SUBJECT: Forwards responses to NRC 950901 RAI re GL 95-03,
"Circumferential Cracking of SG Tubes."

Subject: Oconee Nuclear Station Units 1, 2, & 3
Docket Nos. 50-269, 270, 287
Response to Request for Additional Information Concerning Generic Letter
95-03

OCONEE NUCLEAR STATION
RESPONSE TO RAI FOR GL 95-03

DRILLED ONLY 15th TSP TUBE HOLES

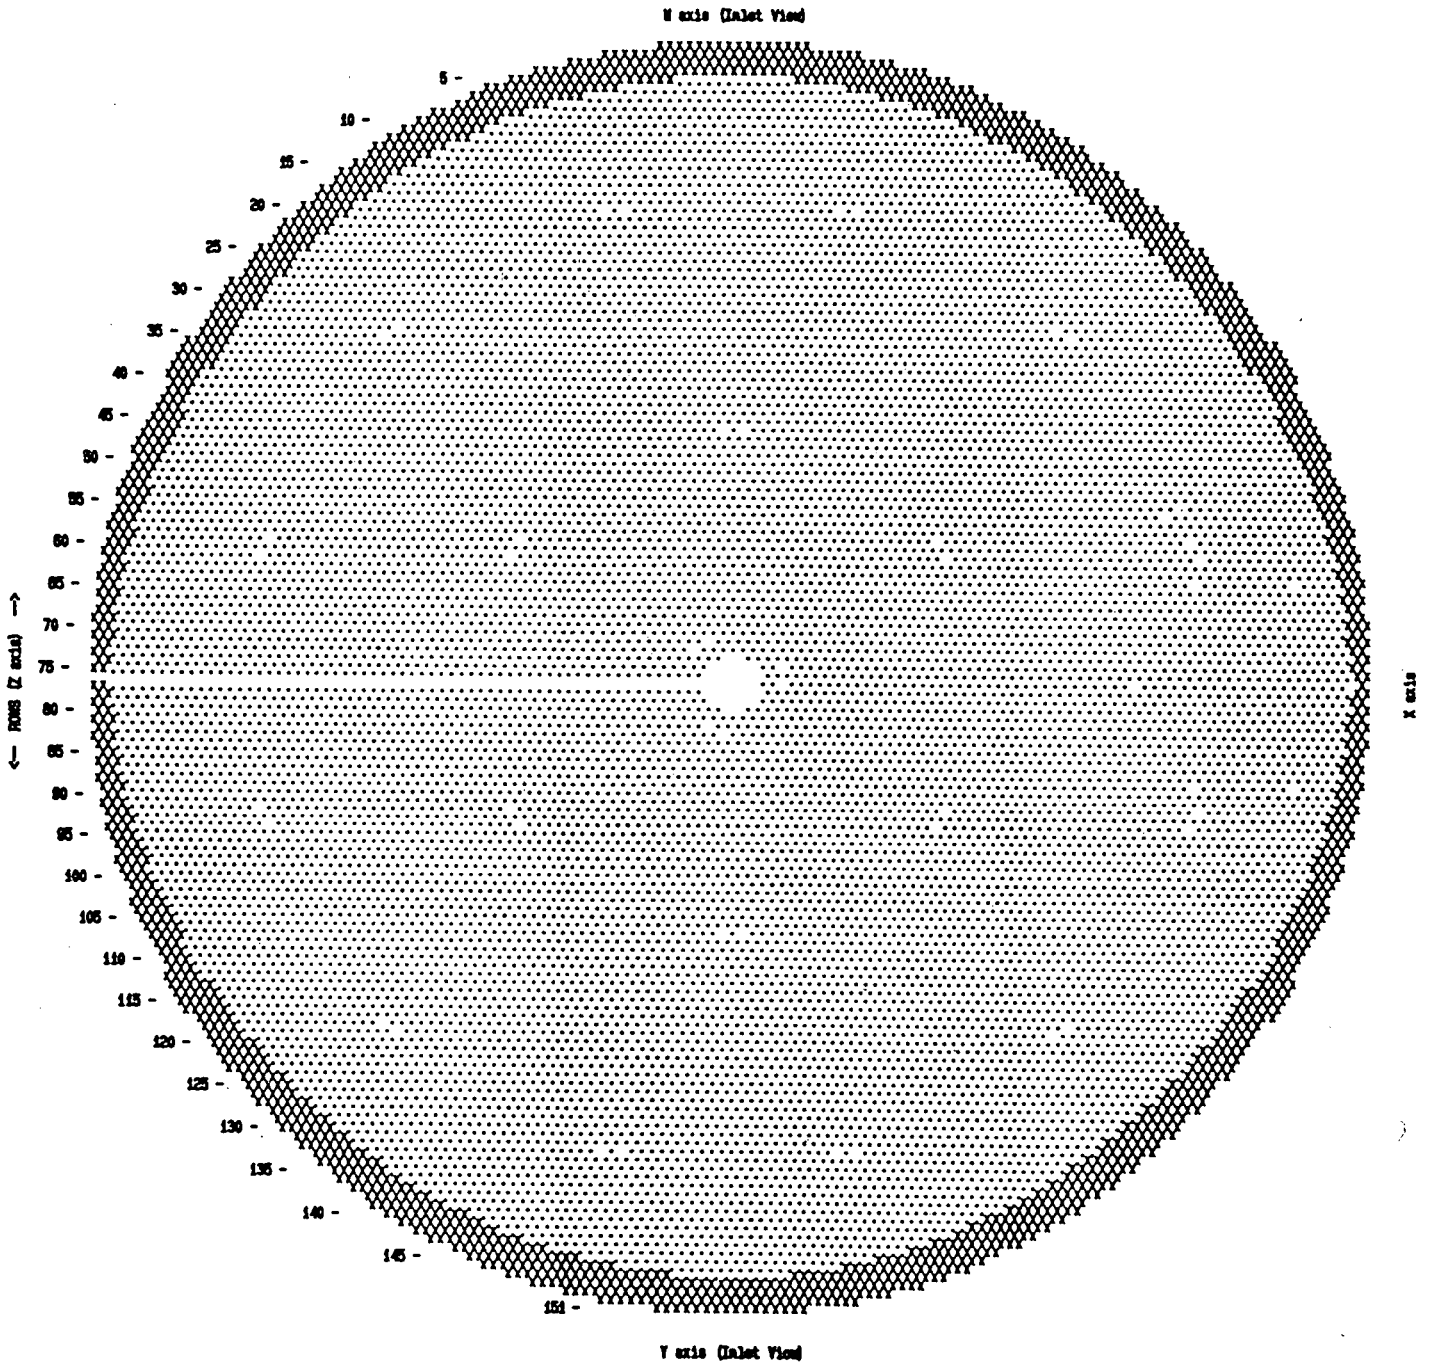
1. Discuss the design differences between the Oconee steam generators and the generic design information provided in the B&W Owners Group response, if any.
2. Dented Regions including dented tube support plates.

EPRI report NP-6201 indicates that the fifteenth tube support plate contains both broached holes and drilled holes. The drilled holes have been prone to denting. Please clarify whether all of the tube support plates are of the broached hole designs or whether a number of them contain drilled holes. Discuss whether denting has been limited to the drilled hole locations, if applicable, or if it has been observed at other support plate intersections (i.e., broached holes).

1. The B&W generic response indicated that all of the TSP's had broached holes. This information is correct except that there are drilled holes around the periphery of the 15th TSP as shown in figure 1.

As indicated in the question 1 response, the drilled holes are located at the 15th TSP. The denting at TSP's has been limited to broached hole locations.
